PD 1521

**DEPARTMENT OF PLANNING AND DEVELOPMENT
CITY OF CHICAGO**

Re: Minor Change for PD No. 1521, 7 W. Elm Street

**Re: Minor Change to Residential-Business Planned Development No. 1521
1120-30 N. State Street – Subarea A**

GROUND PLAN

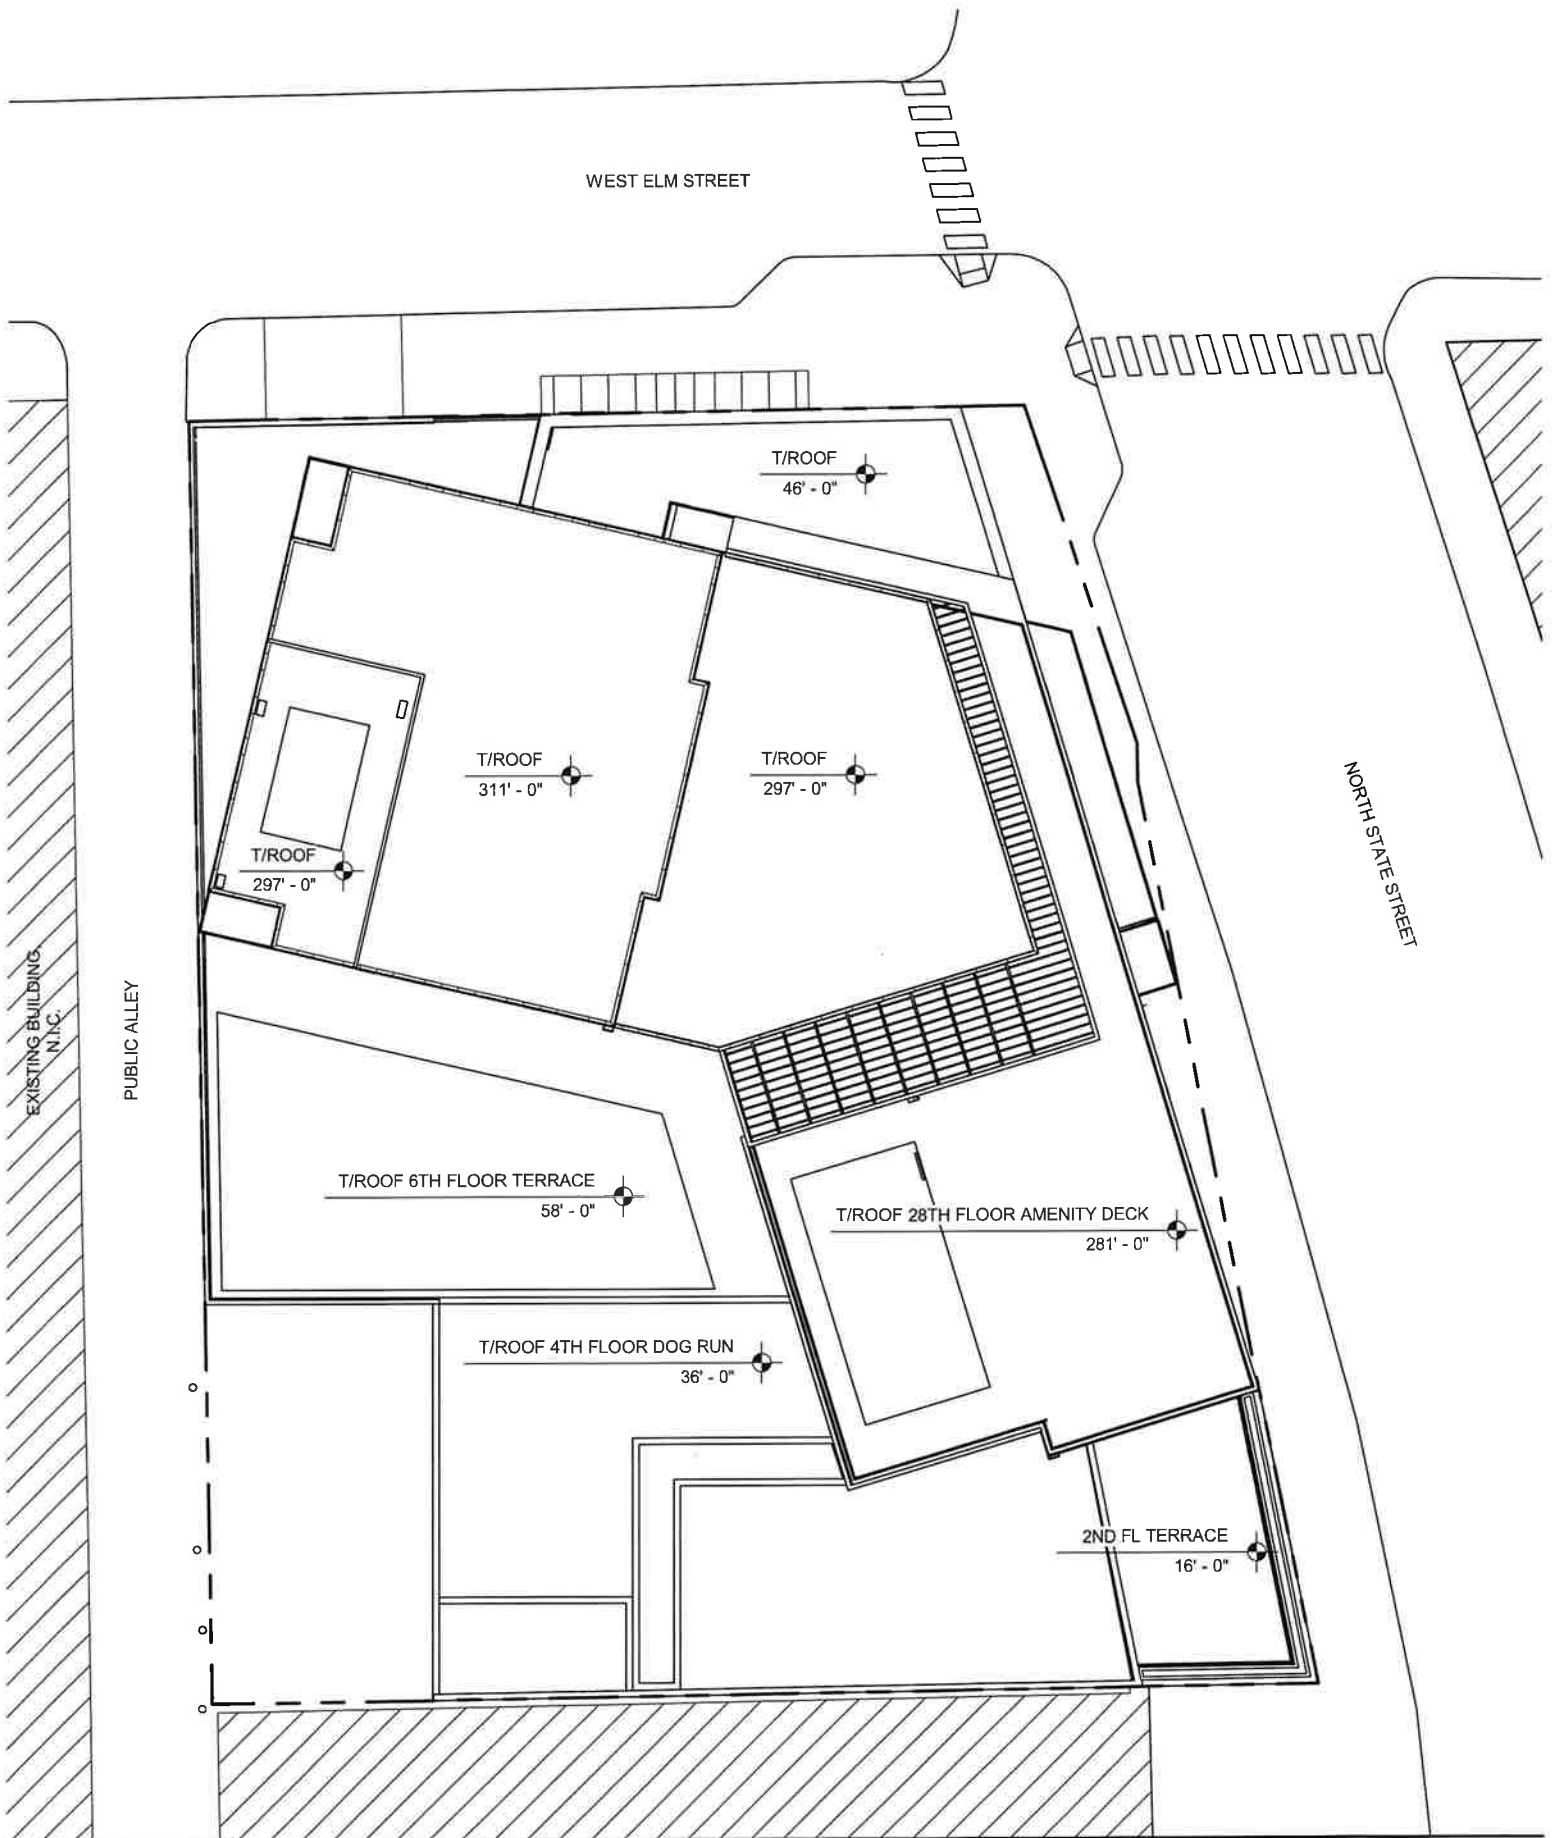
1. Eliminate subareas.
2. Set back the building’s façade from the property line.
3. Provide parkway trees along the State Street frontage.
4. Modify certain upper-level setbacks.
5. Construct the building in a single phase rather than two phases.
6. Set back the tower above the building base along Elm Street.
7. Angle the tower to increase the upper-level setback at the Elm/State corner of the site.
8. Reduce the maximum building height from 351 feet to 312 feet.
9. Reduce the total floor area ratio (FAR) from 11.5 to 11.15.
10. Reduce loading spaces from three to two.

NORTH ELEVATION

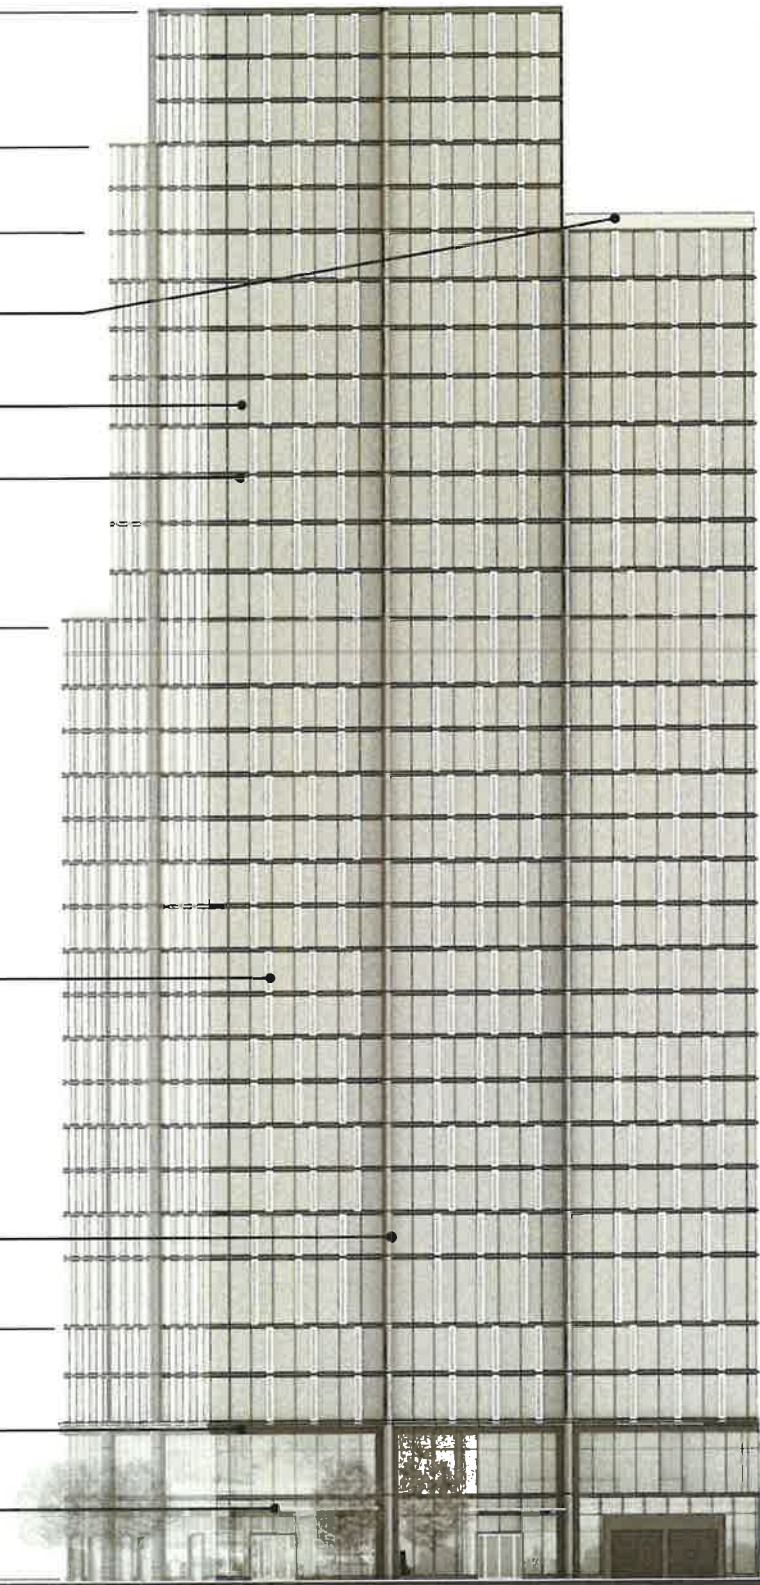
Quick’s LLC, the owner of Subarea A in PD 1512, is seeking a minor change to increase the maximum permitted building height of 345’ in Subarea A in PD 1512 to 351’. During the final design, several slight changes have caused a 6-foot (i.e., less than 2%) height increase. Specifically, Developer requests the following height increases:

- A 1’-0” increase at Level 05 as a result of needing more system depth to accommodate plumbing and mechanical transfers, and the exterior slab level change for the green roof;
- A 1’-0” increase at Level 20 as a result of needing more system depth on the south elevation at the exterior massing change for green roof drainage and ceiling plenum space for plumbing and mechanical transfers;
- A 1’-0” increase at Level 21 as a result of needing more system depth to accommodate plumbing and mechanical transfers, and the exterior slab level change for the green roof;
- A 1’-6” increase at Level 29 as a result of needing more system depth to accommodate structural, plumbing and mechanical transfers; and
- A 1’-6” increase at Level 30 as a result of needing more system depth to accommodate structural, plumbing and mechanical transfers.
